# Introduction

## Purpose of this Report

This Response to Submissions Design Report has been prepared by Foster+Partners on behalf of the Pitt Street Developer North Pty Ltd to address the matters raised by government agencies, the public and community organisation groups during public exhibition of the proposed Sydney Metro Pitt Street North Over Station Development (OSD) State Significant Development (**SSD**).

Effective Glazing & Facade treatments (Tower)

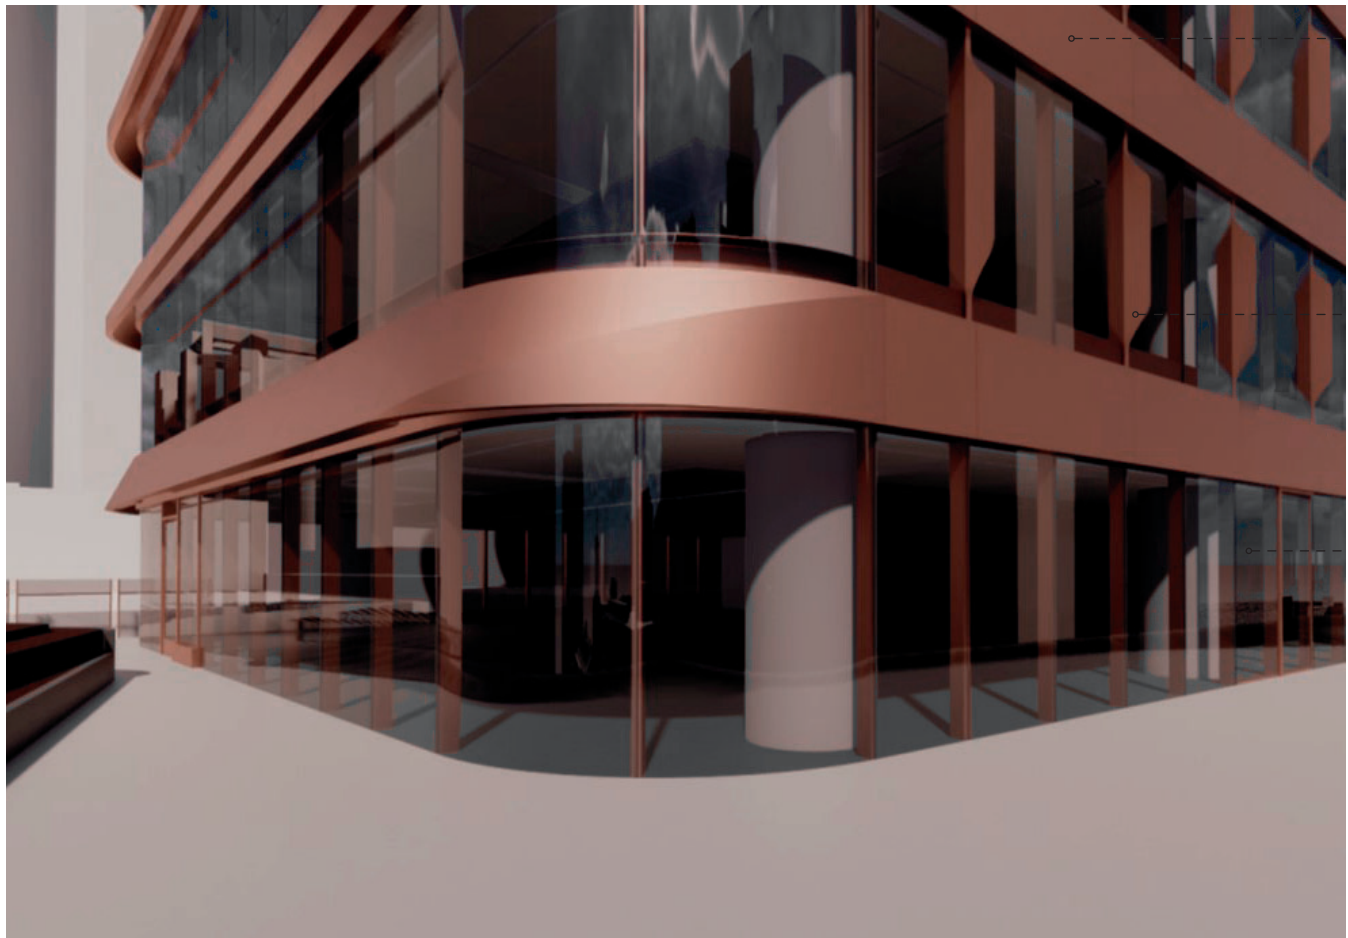
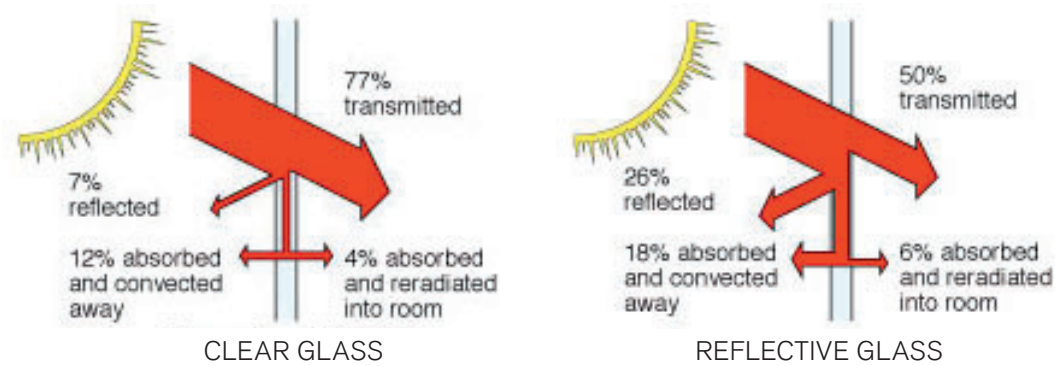
*The City requests the applicant provide details of a localised translucent glazing treatment that will ensure the glazed screen is visible to birds, particularly any threatened or vulnerable species and species of local conservation significance (refer to the City’s Urban Ecology Strategic Action Plan).*

*Detail of proposed typical L10 balustrade*

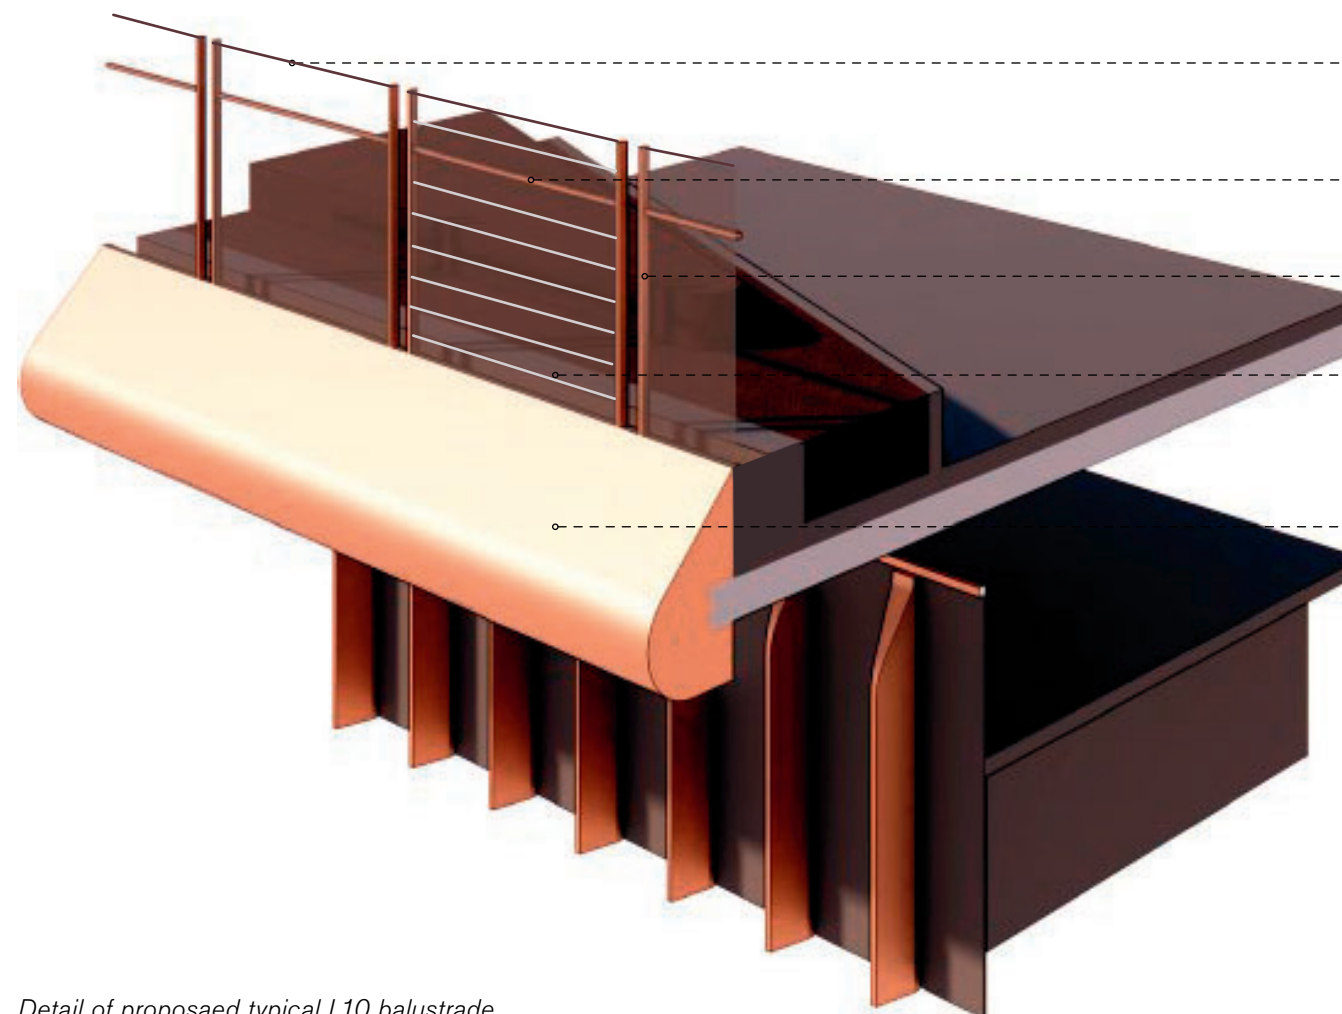
***The City requests the applicant provide details of a localised translucent glazing treatment that will ensure the glazed screen is visible to birds, particularly any threatened or vulnerable species and species of local conservation significance (refer to the City's Urban Ecology Strategic Action Plan).***

The 2 x 4 Rule

View at base of the NSW Masonic Club lightwell

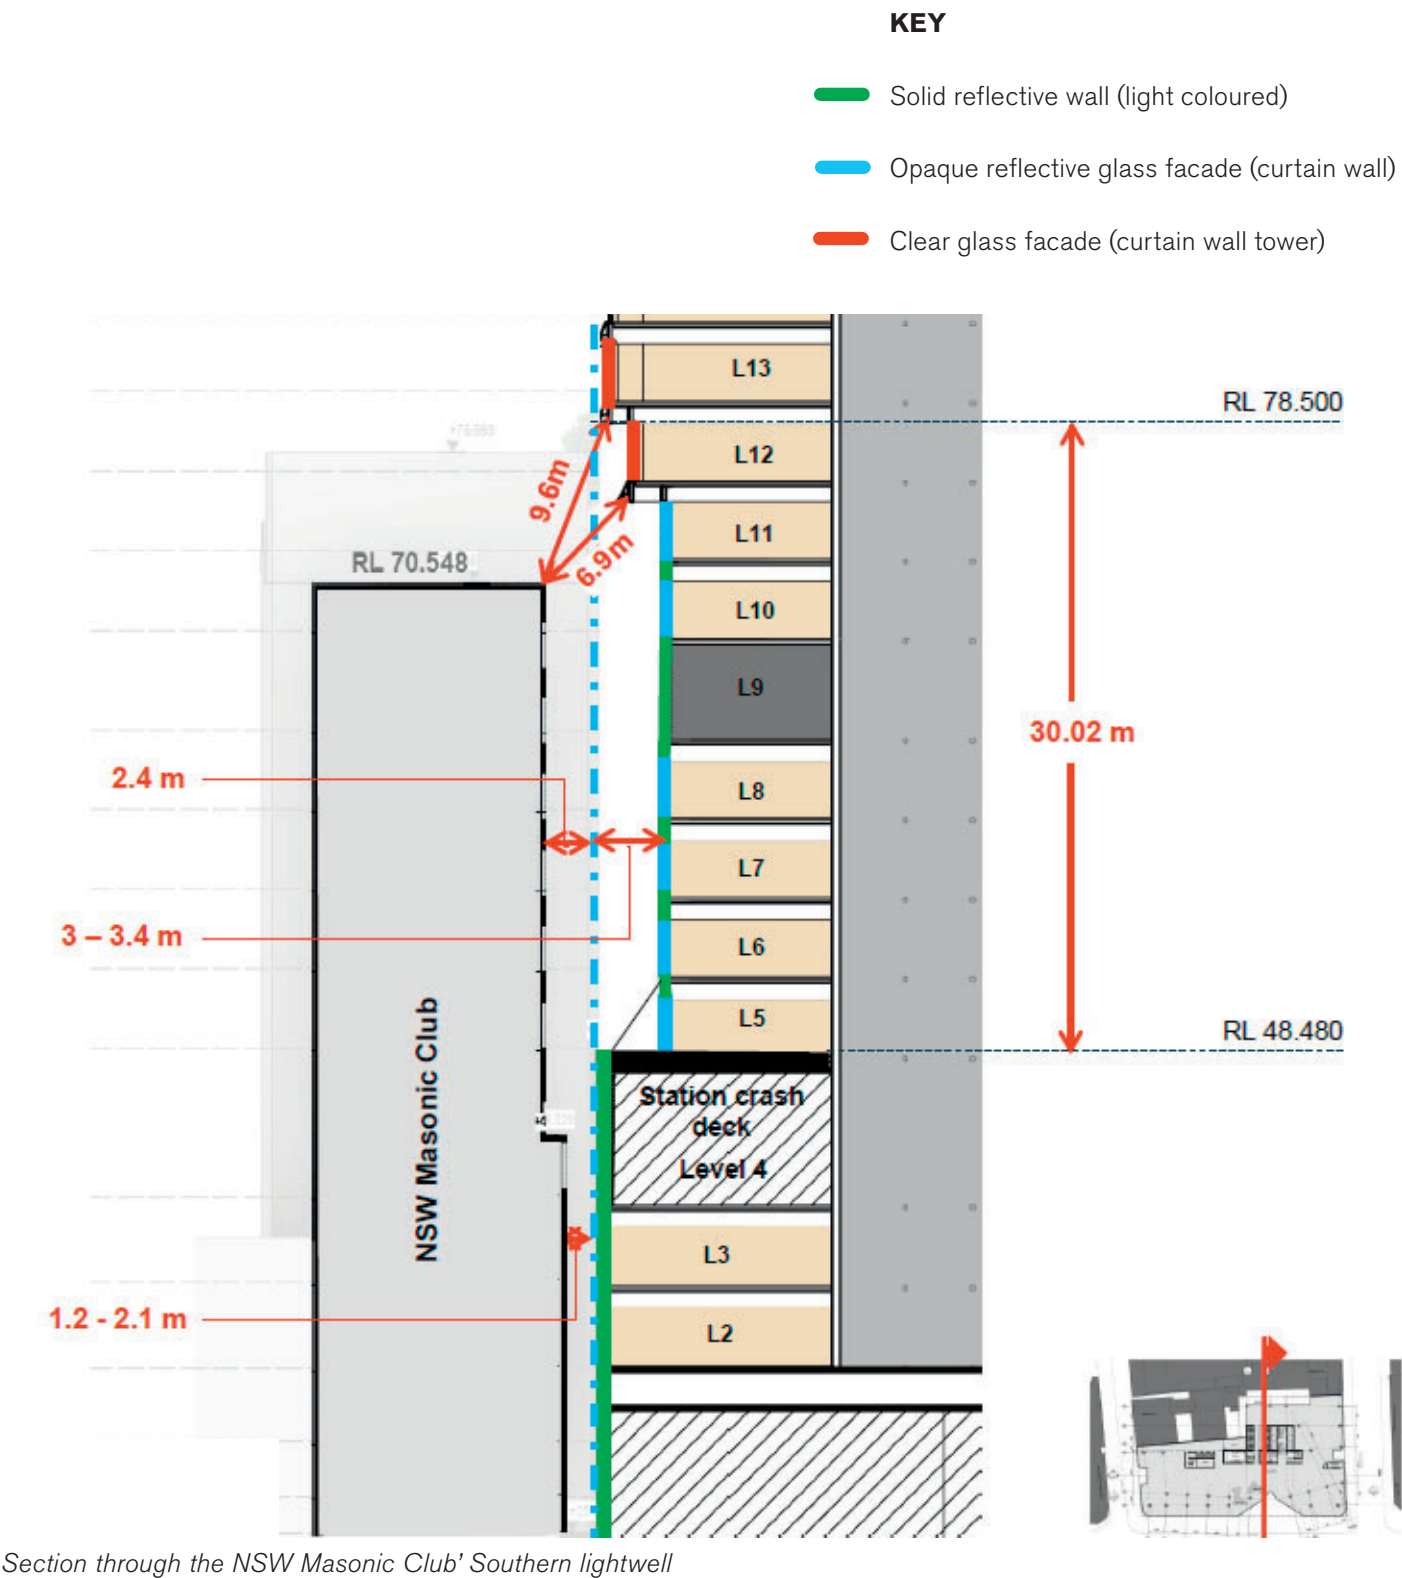
*The Club notes the use of light and reflective cladding materials to the walls of the proposed building which face into the lightwell. Instead of the proposed translucent glass of light-coloured material currently proposed, the Club would support an attractive, decorative mural to provide a better outlook for hotel guests.*

The current design, the detailed expression and materiality of the OSD facade facing the Masonic light well, complies with the project requirements established in the OSD, North Design Parameters during the RFT phases of the project.

As can be seen on the pictures taken from within the NSW Masonic lightwell, a great number of services (cables, pipes, mechanical flues and duct work) are running across the southern lightwell elevation. In its current state, all NSW Masonic Club windows below Level 4 have been blanked out or filled in. Above level 4 all windows facing into the lightwell currently incorporate opaque textured glazing thus preventing a clear view into the lightwell. If in the future the windows to the Masonic hotel rooms would be made clear, the outlook for the building users would be a pleasant looking modern facade, reflecting a maximum amount of sunlight into the lightwell.

### Castlereagh Street Streetscape

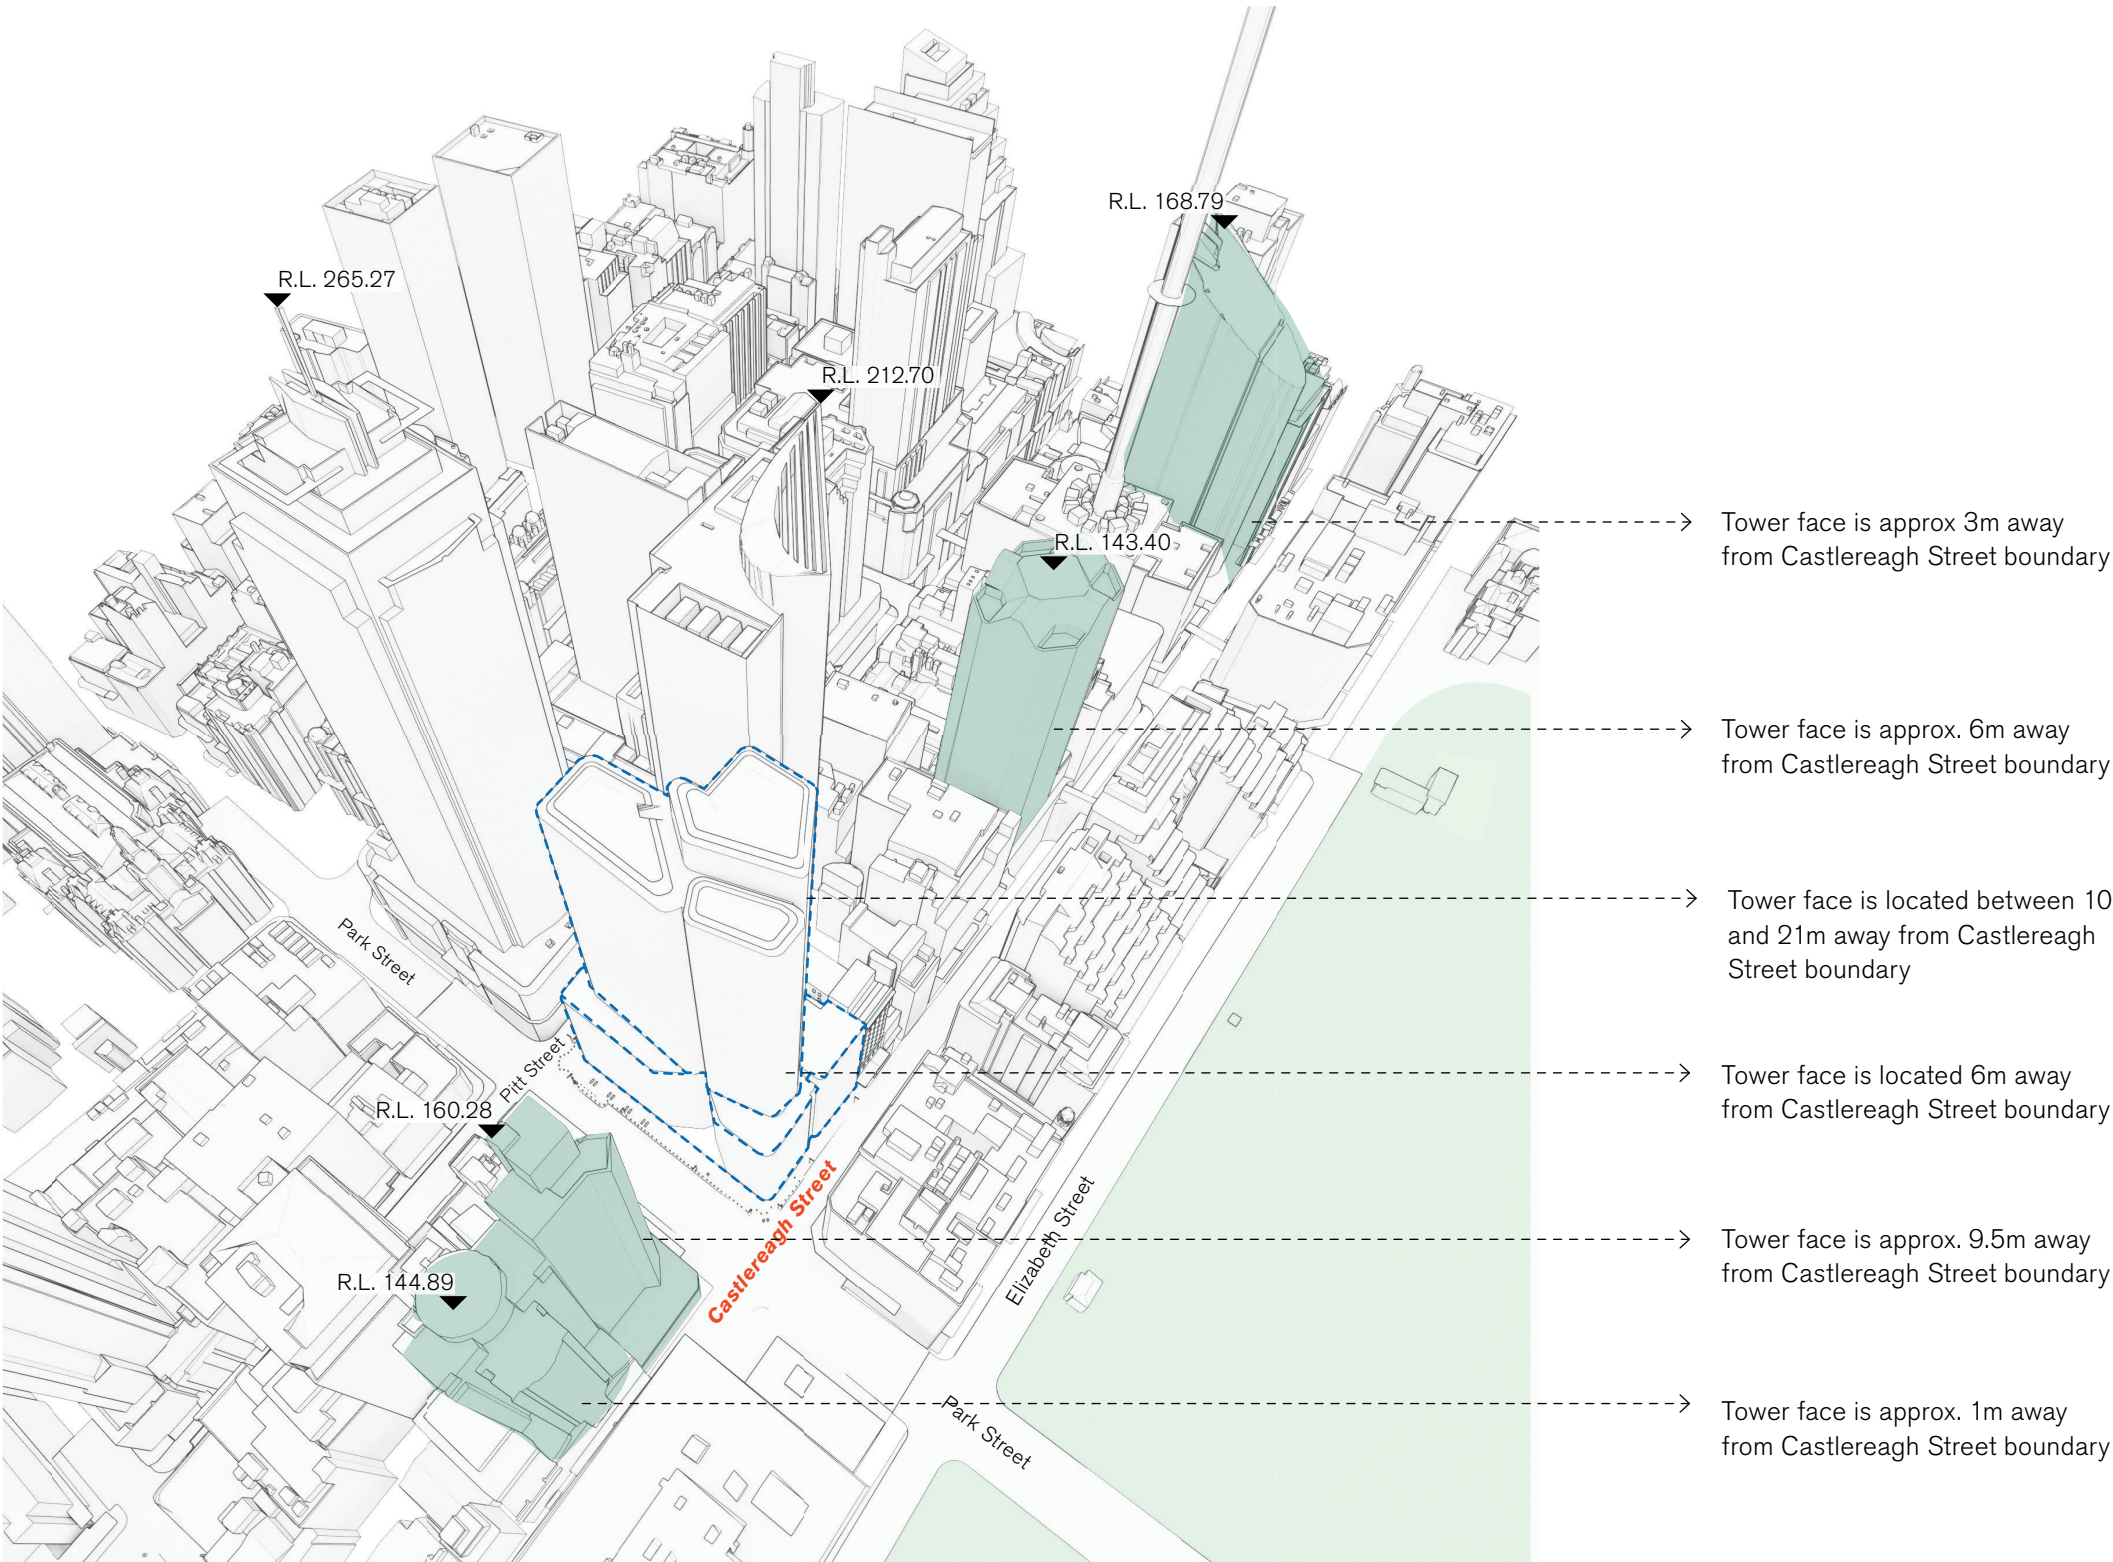
**Objects to the bulk of the project as seen from Castlereagh Street. The building should be set back much further from the Castlereagh Street frontage. Most existing high-rise buildings are set back from the Castlereagh Street frontage which opens up a city view. As currently designed, it blocks the view of the cityscape and Centrepont tower in particular.**

The following images show the additional views to Hyde park and architectural landmarks within and around Hyde Park that will be visible from the western most apartments and the apartments located at the North-Eastern corner of the Park Regis tower, when comparing the current SSDA massing with the approved Stage 1 envelope.
